**SECTION 00 9112
ADDENDUM NUMBER TWO**

PROJECT: IOWA STATE FAIR – SWINE-CATTLE BARN UPDATES – PHASE 1

RE: Structural Addendum

PROJECT : ISF Swine – Cattle Barn UPDATES – Phase 1

S501-1

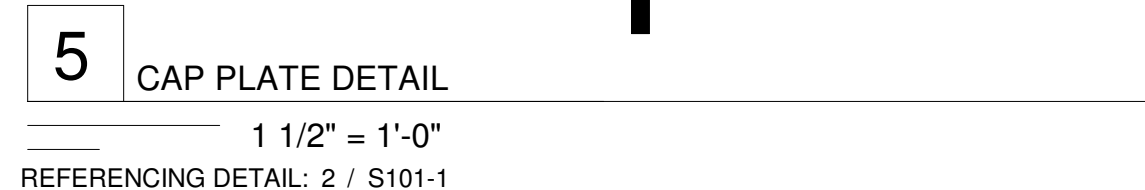
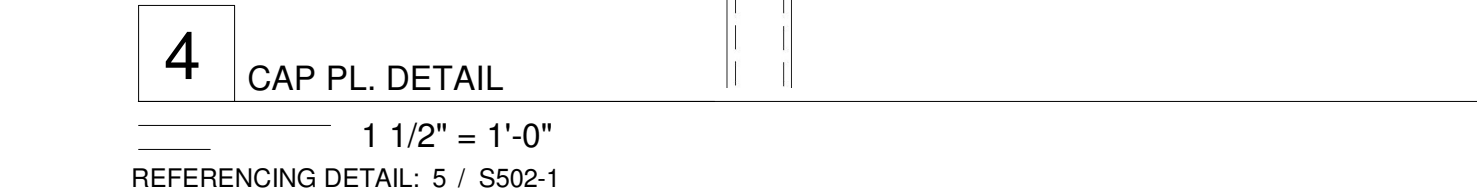
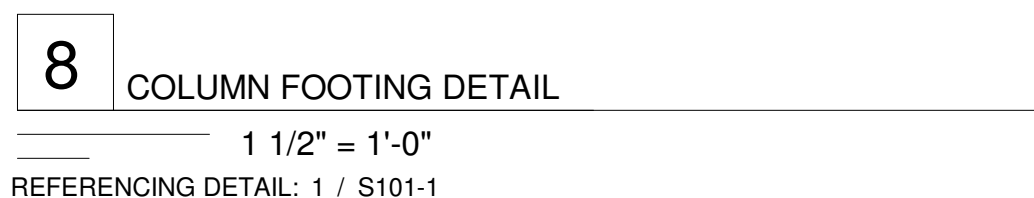
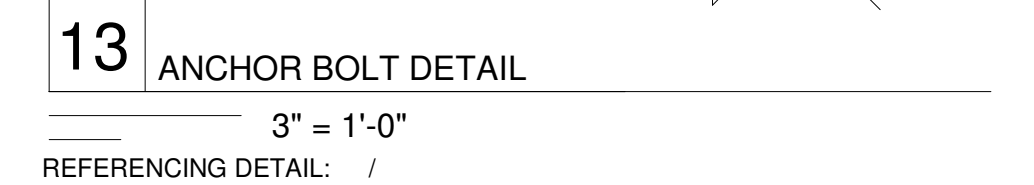
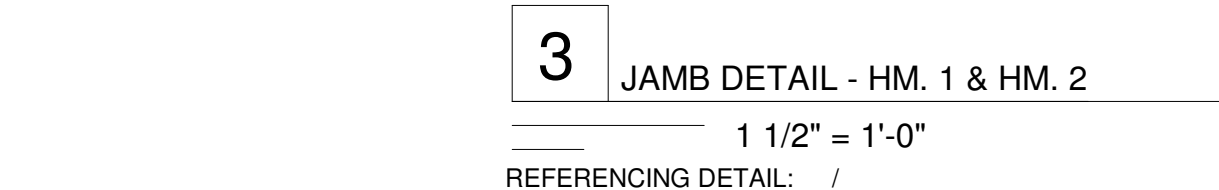
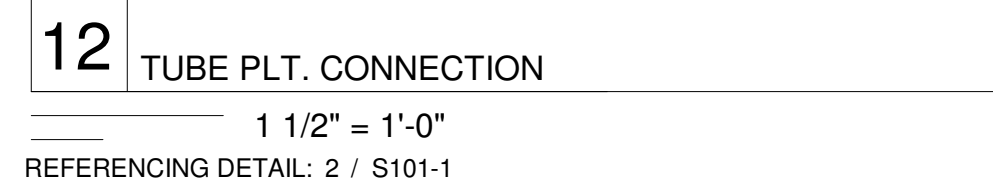
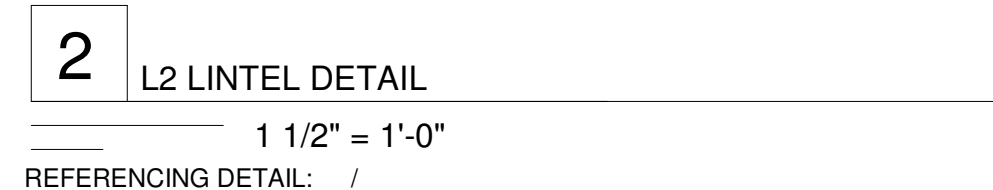
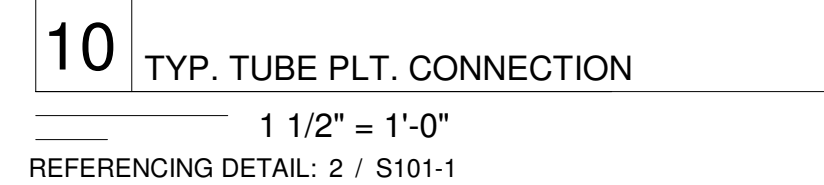
7. Change detail 13/S501-1. Change 3'-0" overhang at East to be 3'-0" to the inside face of the double fascia boards. Match 11/S501-1. See architectural.
8. Change detail 13/S501-1. Change 2'-0" overhang at West to be 1'-8" to the inside face of the double fascia boards. See architectural.
9. Add to section 1&13&15/S501-1. Add 4" compacted granular subbase under chase slab.
10. Revised detail 1/S501-1 to eliminate starter wall at the chase wall. Masonry bears at -1'-2". Add note to starter wall "BEYOND".
11. Change 1&17&18/S501-1 Title to WALL SECTION.
